CAMPER MOUNT REPLACEMENT

Subject: SAFETY RECALL Required Front Camper Mount Inspection and Replacement	Bulletin No: 0008 rev C
	Issued: 12/28/2006

SAFETY RECALL – CAMPER MOUNT REPLACEMENT

Passenger Side

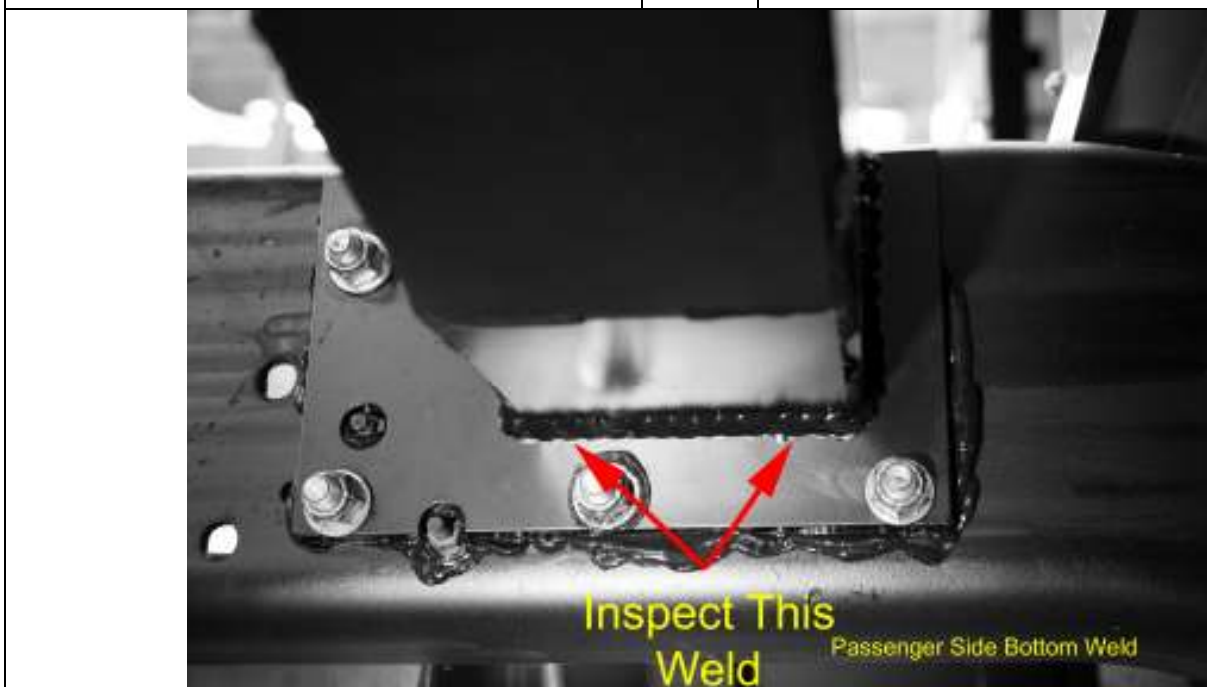
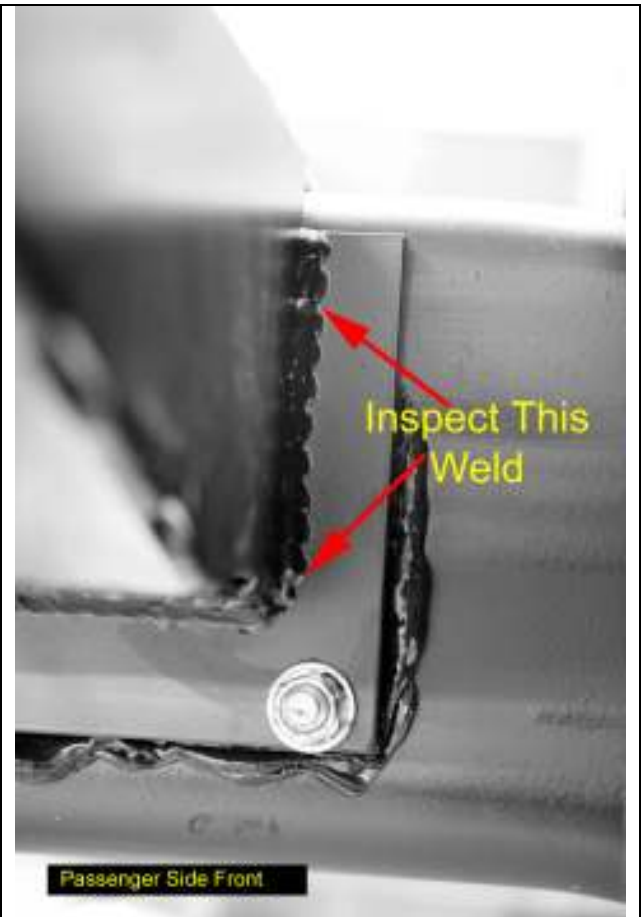
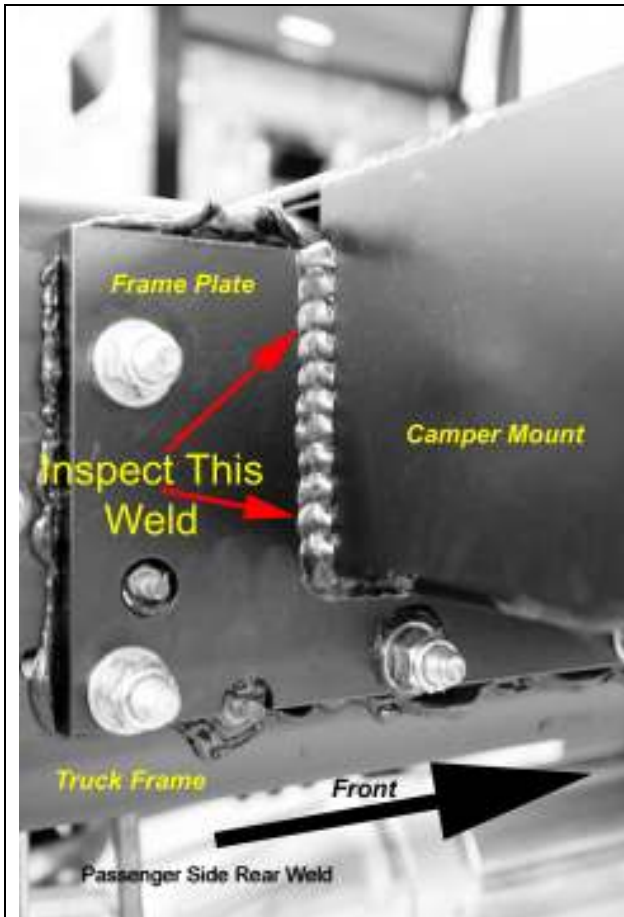
2. The area to be inspected is located between the truck frame and fiberglass camper body fairing.
3. The welds that attach the frame plate to the camper mount need to be visually inspected for any signs of cracking. Clean the area as needed to provide clear viewing of the area of concern. There are a total of 6 locations that need to be inspected (three on the passenger side mount and three on the drivers side mount). The photos below show the front mount assembly prior to installation of the camper body to clearly illustrate each of the weld locations. There is also a photo included of an actual mount on a completed vehicle to more clearly represent at what you will be looking.

Camper mount before camper has been installed. These photos show revision D mounts with a continuous weld bead. Your mounts will be stitch welded.

All revision B or C front camper mounts will need to be replaced with current revision mounts as soon as feasibly possible to ensure driver safety. Each circumstance will be addressed and the repair method handled individually.

Driver Side

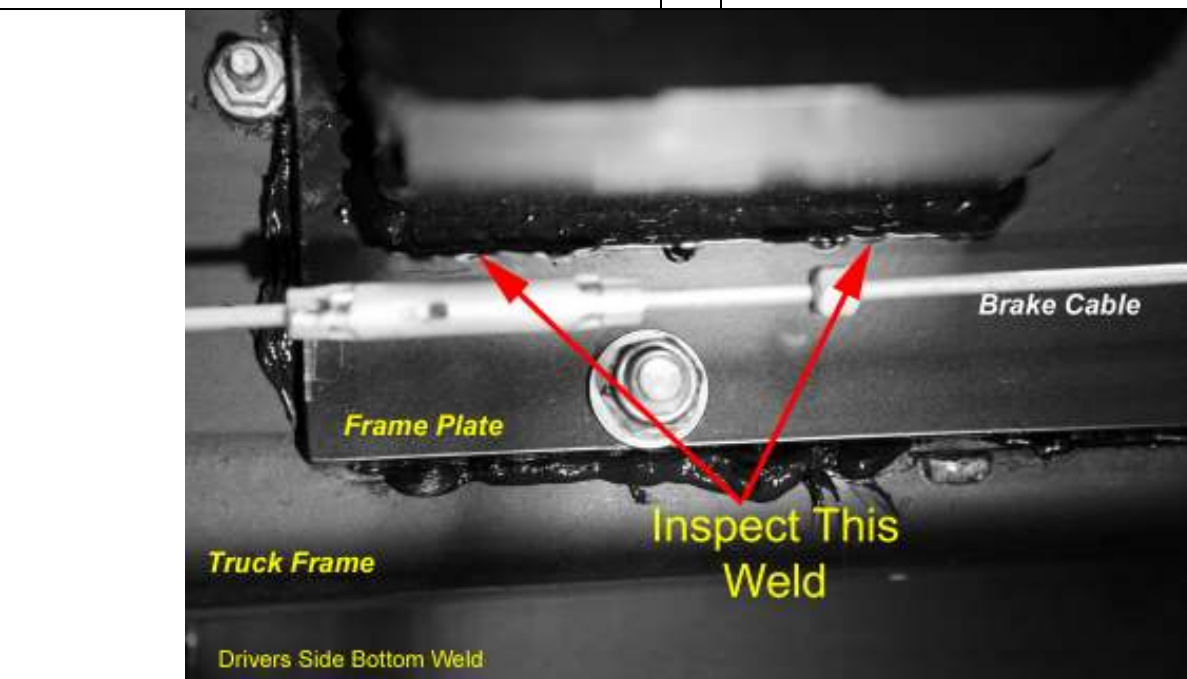
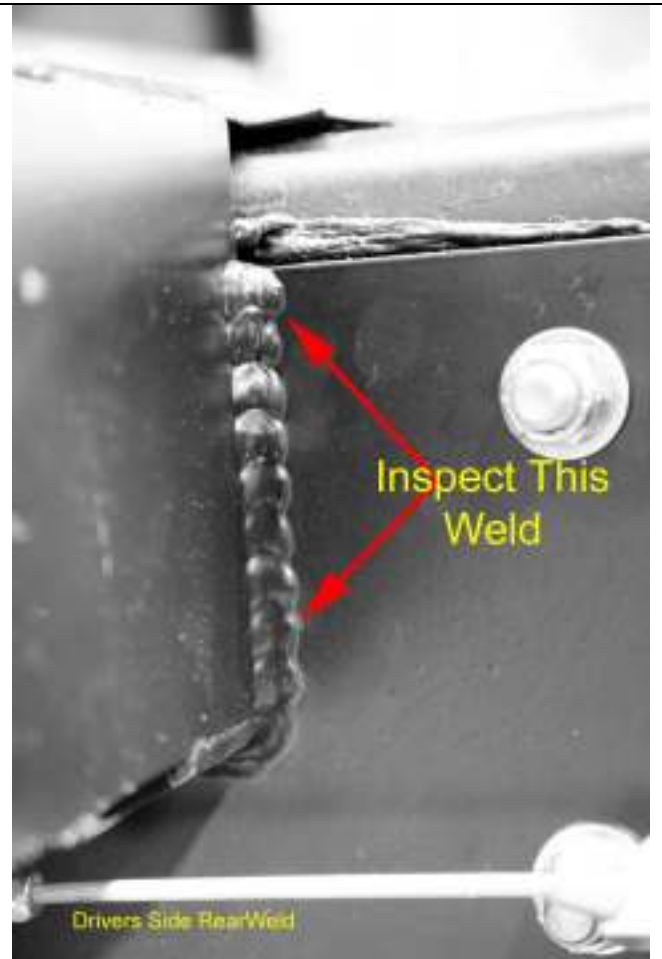
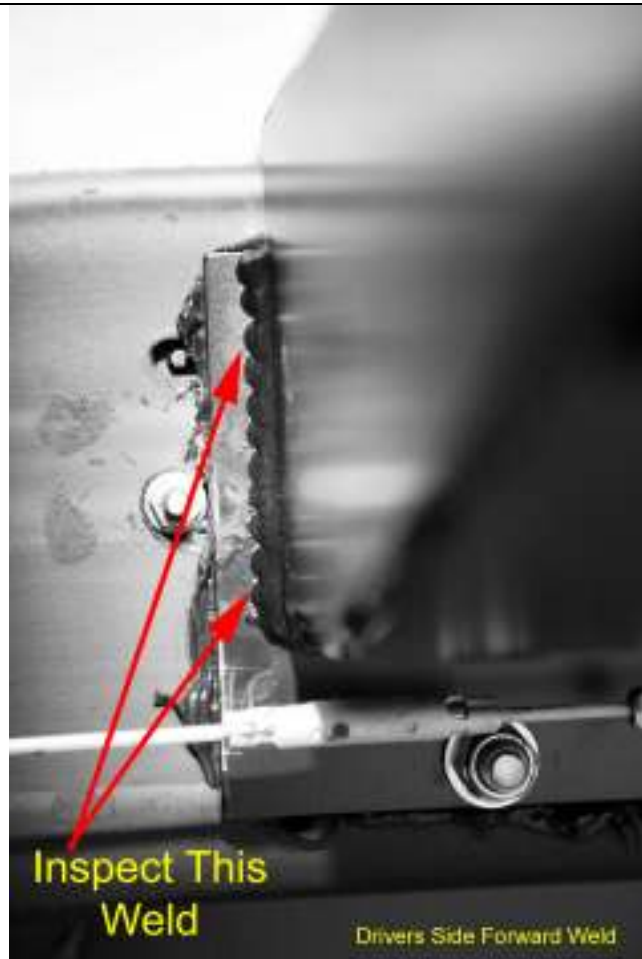
Camper mount before camper has been installed. These photos show revision D mounts with a continuous weld bead. Your mounts will be stitch welded.

Camper mount after camper has been installed
